DEVELOPMENT REVIEW

Project description Applicant is proposing two commercial buildings totaling 88,748 sf of office / flex space and a 33,190 sf building for RV storage with associated site improvements.

**Re: 2564 S. Kings Highway – Development & Design Review
TRC Response to Comments
TRC Project # 20-07000002**

On behalf of our client, please find the attached response to comments received on March 18, 2021 for a project known as Walsh Kings Highway. Each comment is identified below followed by a response in ***bold italics***.

Landscape Plan

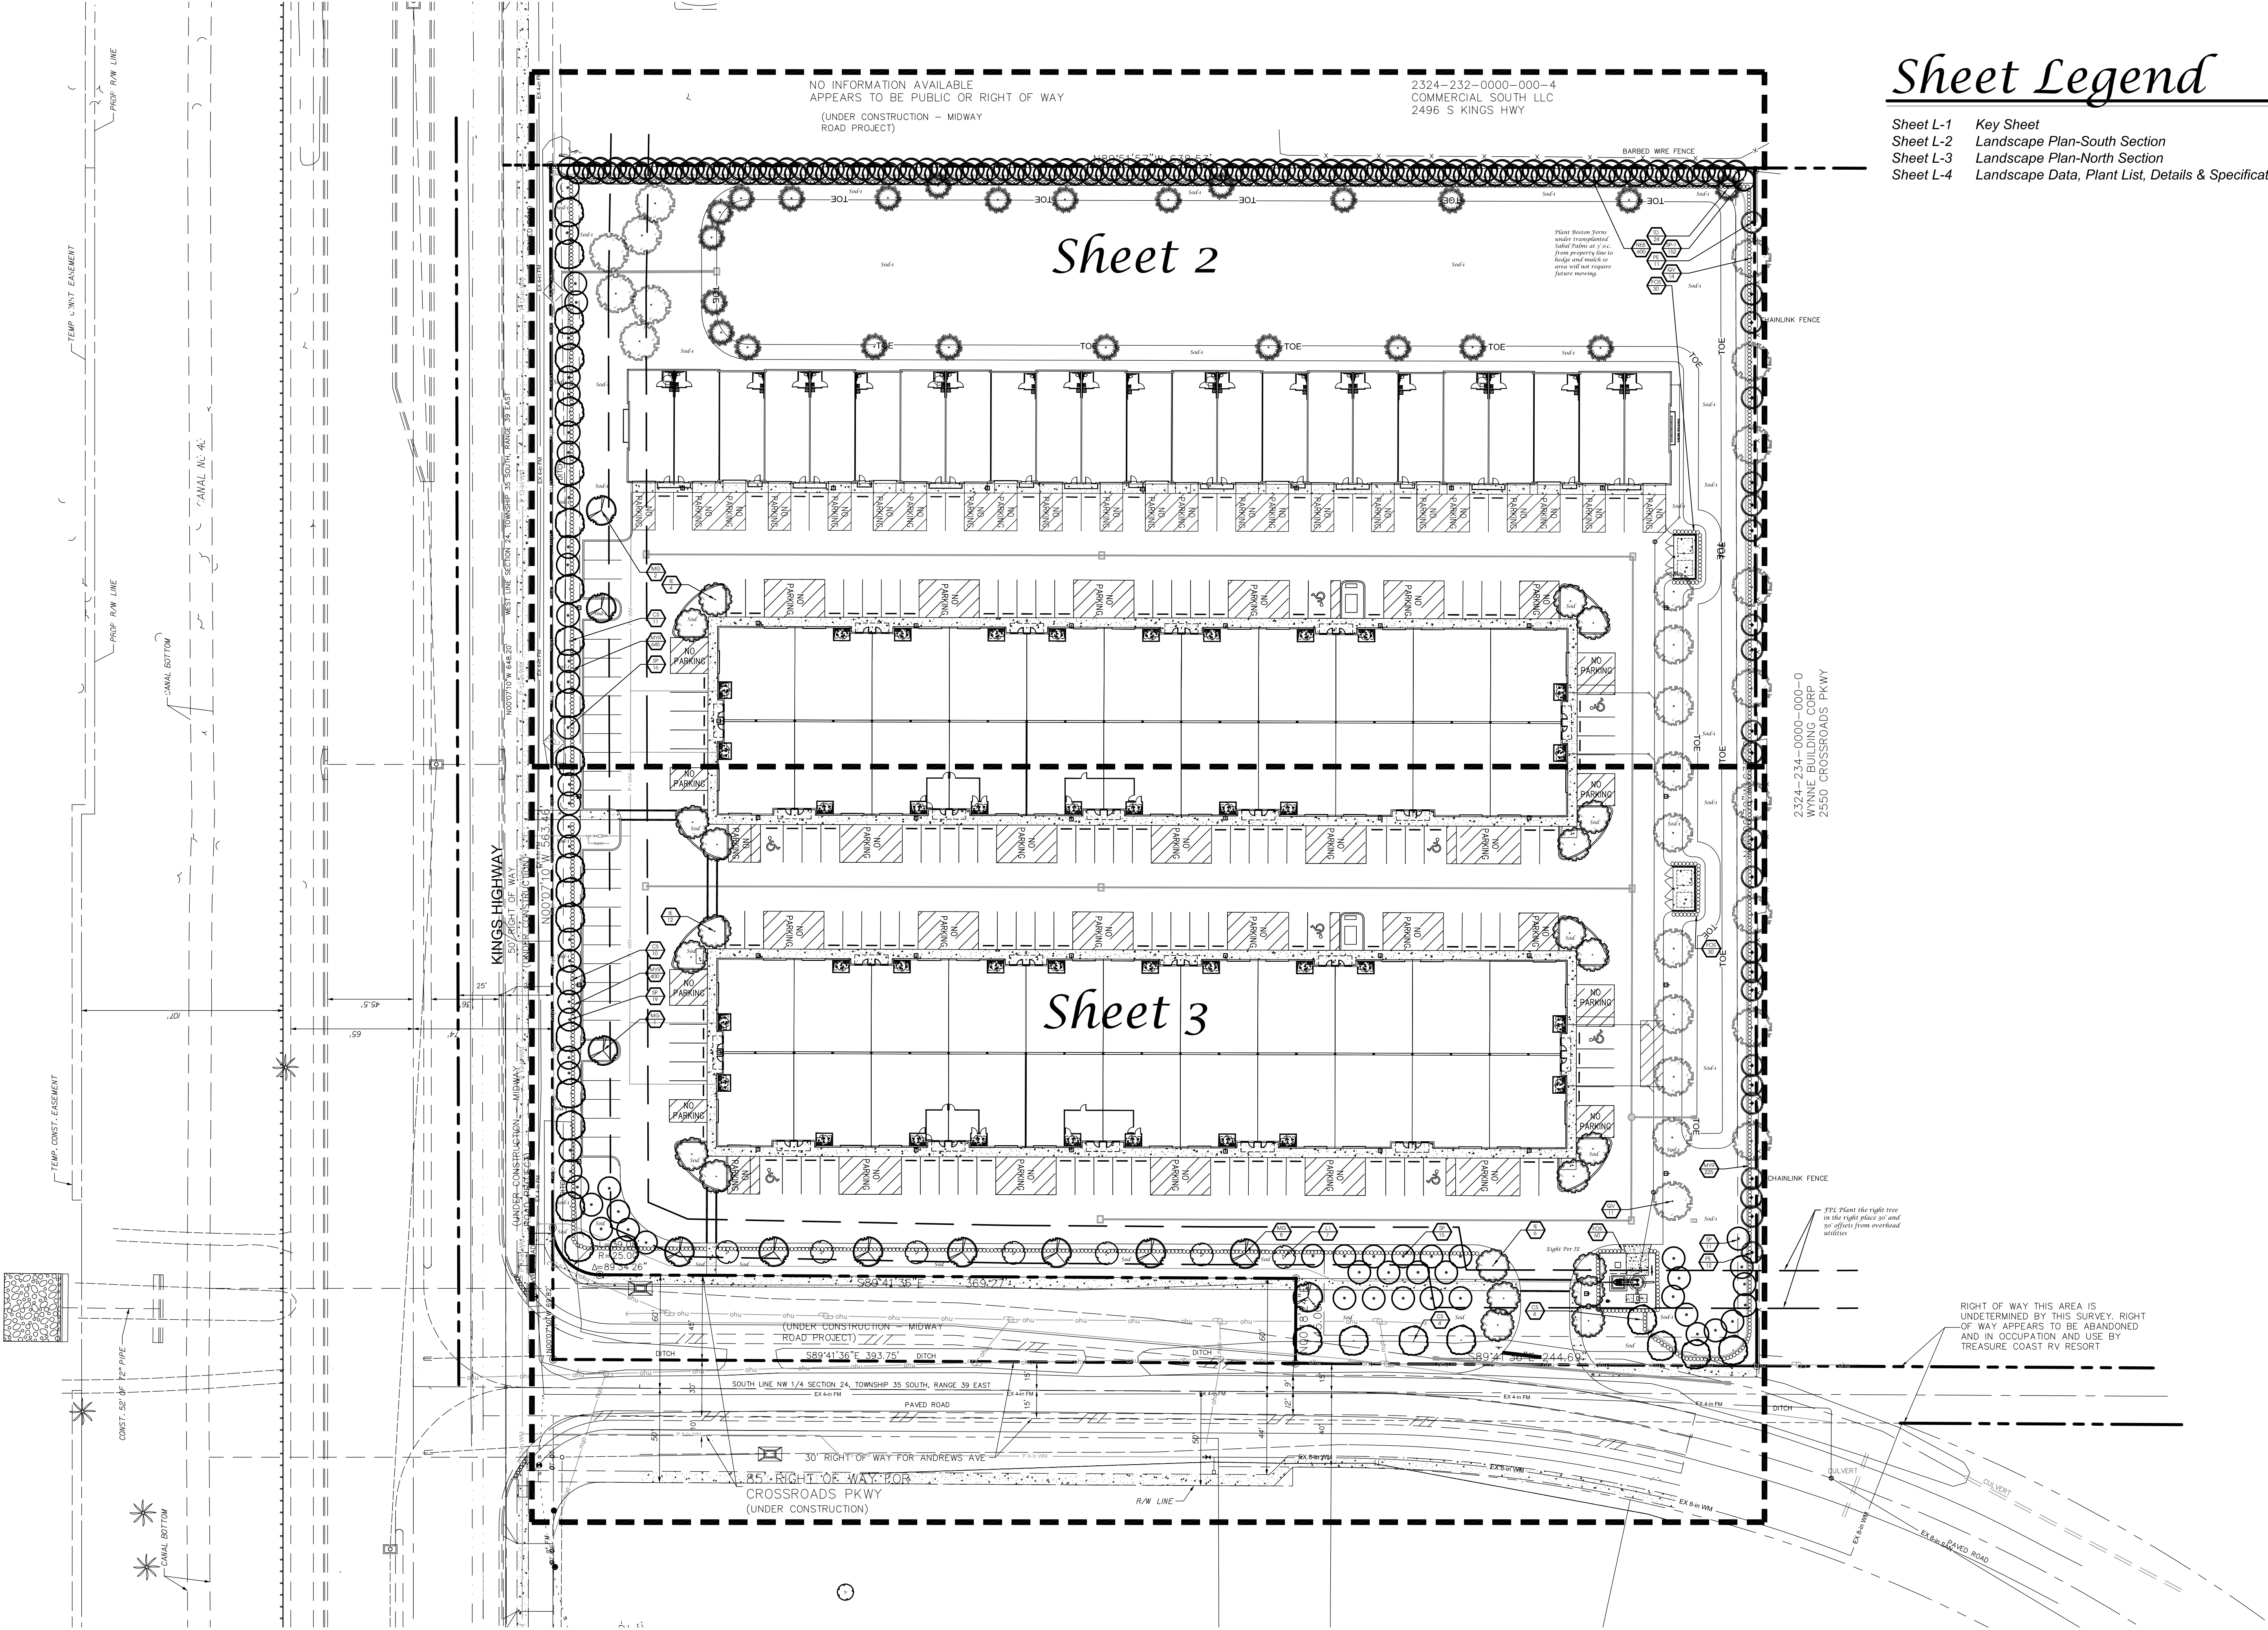
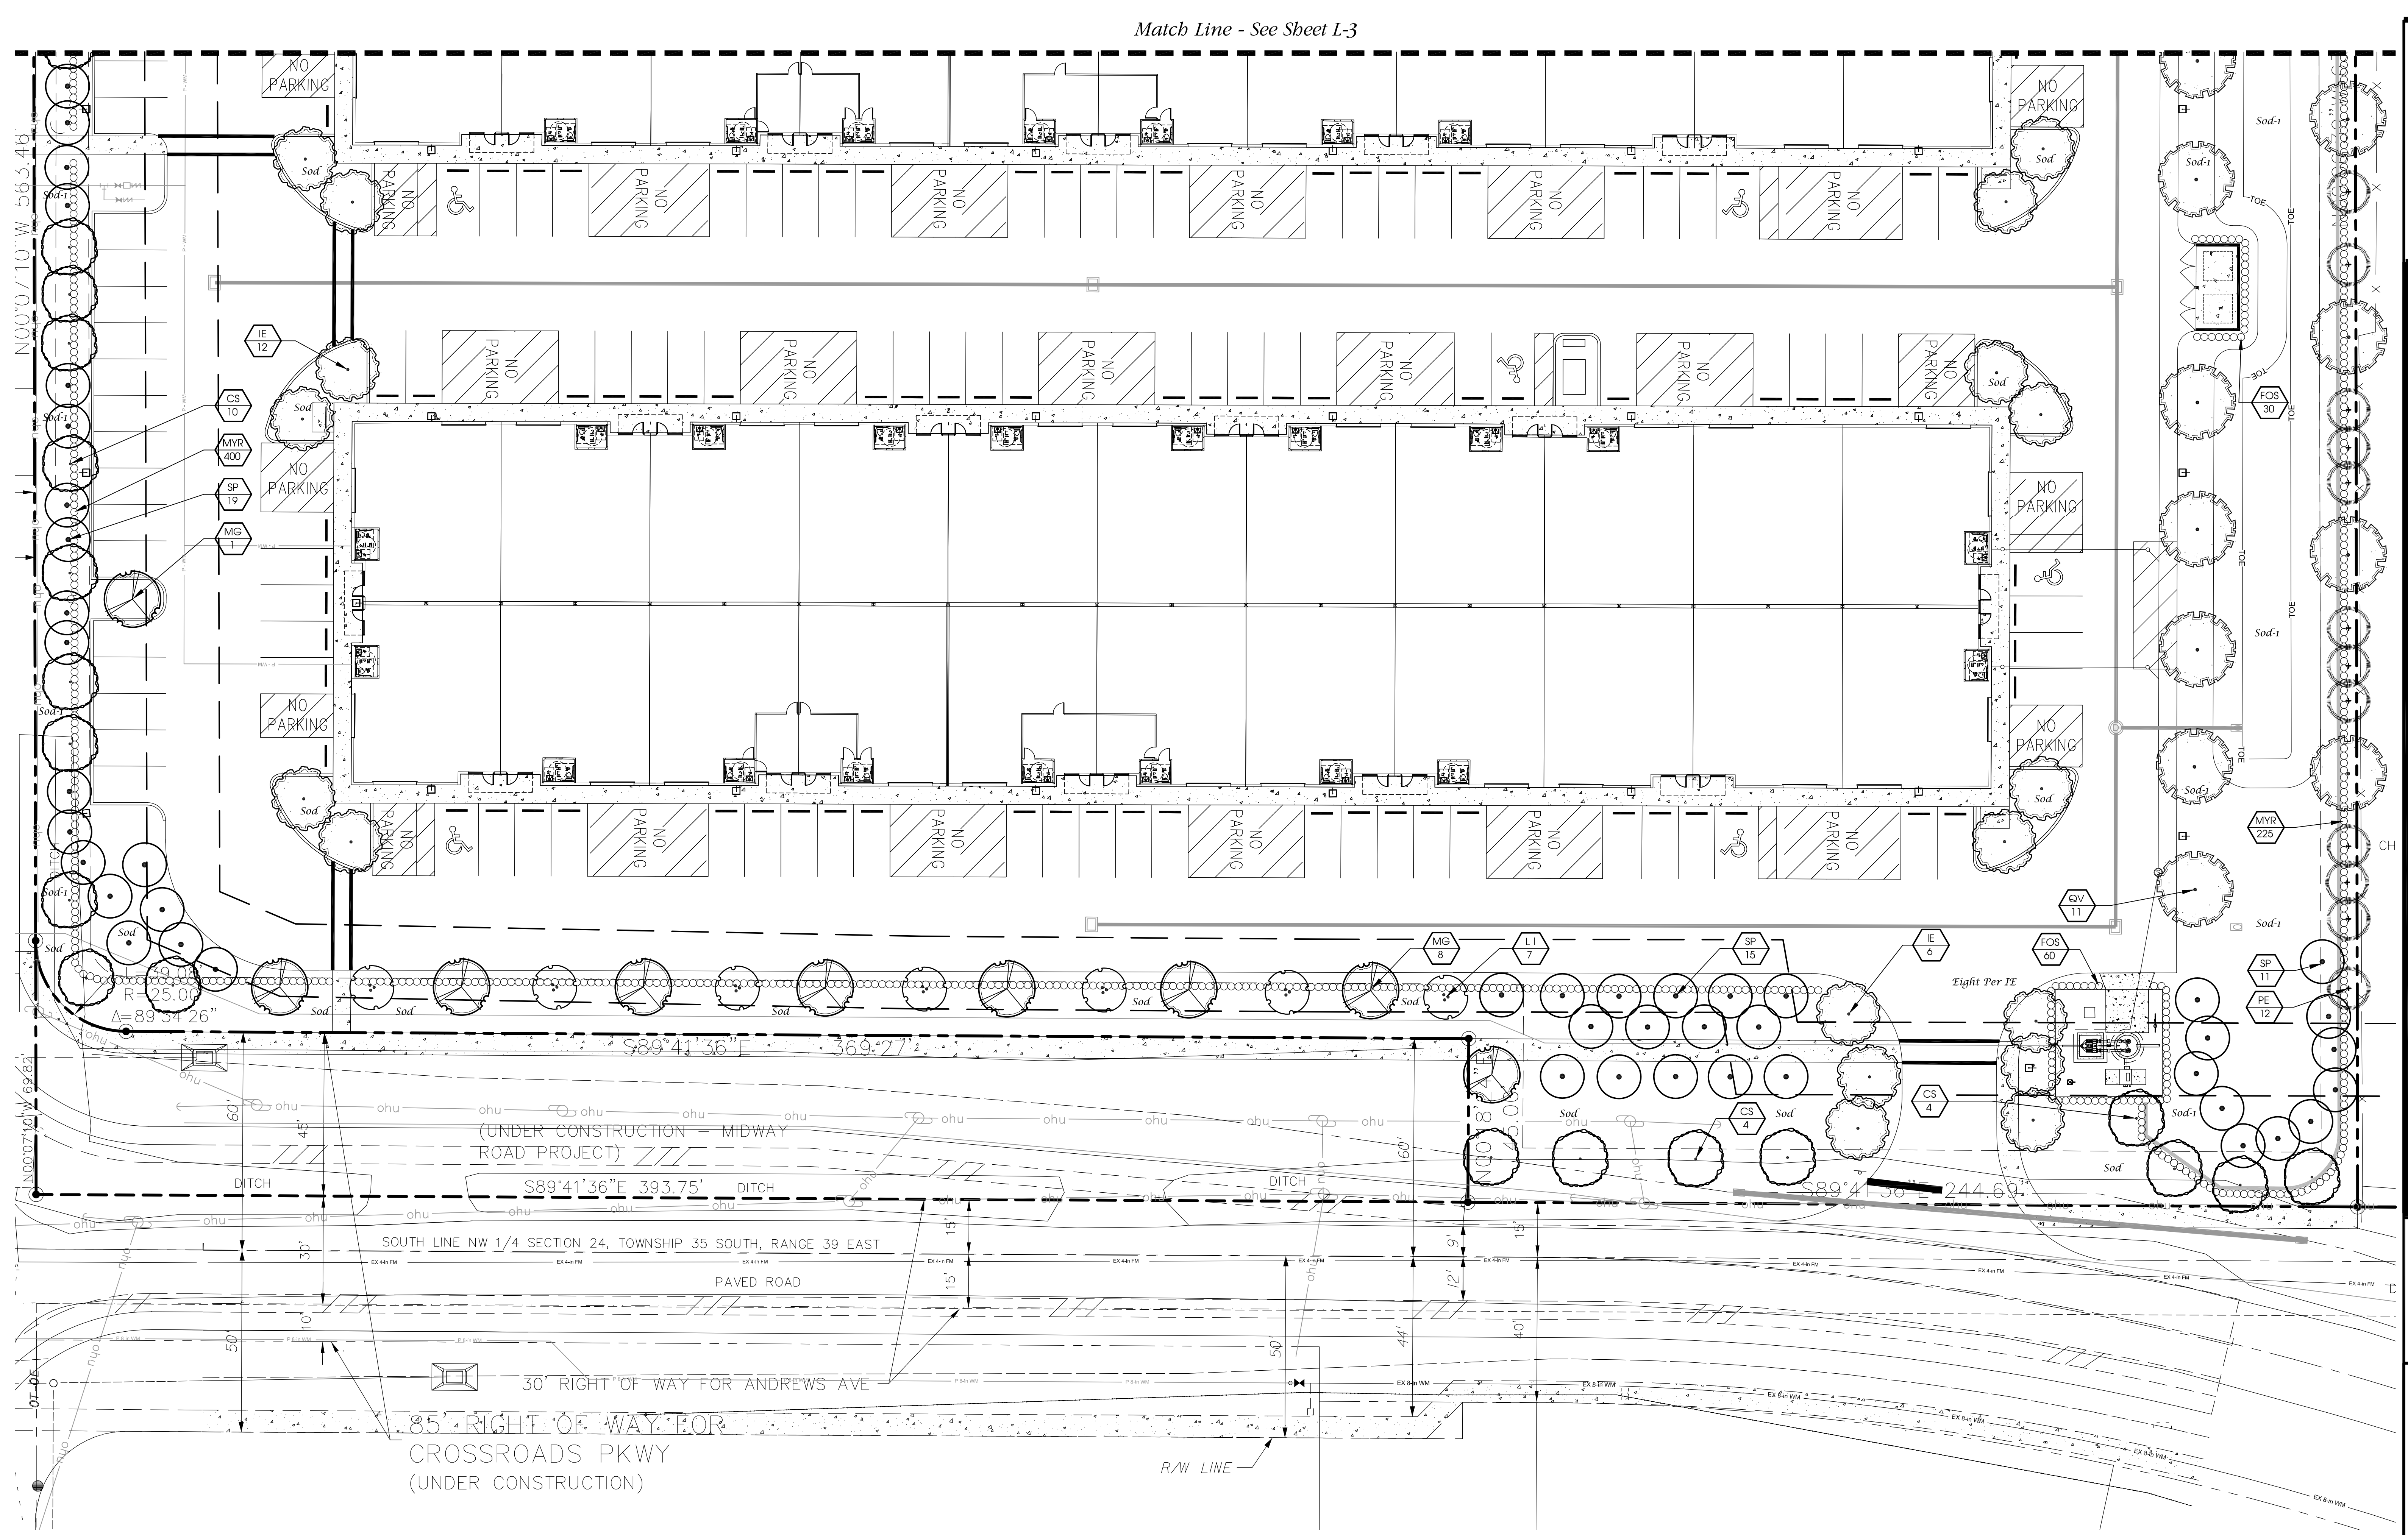
8. A tree mitigation plan was not found with the landscape plan, provide this plan to show all trees that will need to be mitigated for based on the site plan. Also calculate the trees that will either be saved, relocated, or planted and come up with the required mitigation calculation if mitigation will be required. Overall, the provided landscape plan appears to be consistent with code.

9. Provide some landscape design elements to the detention area.

RESPONSE: *Please find the attached arborist report that calculates the required tree mitigation at \$ 62,998.57.*

RESPONSE: *Please see revised site plan and landscape plans. The addition of*

buffering by the detention area to screen it from view has been added.
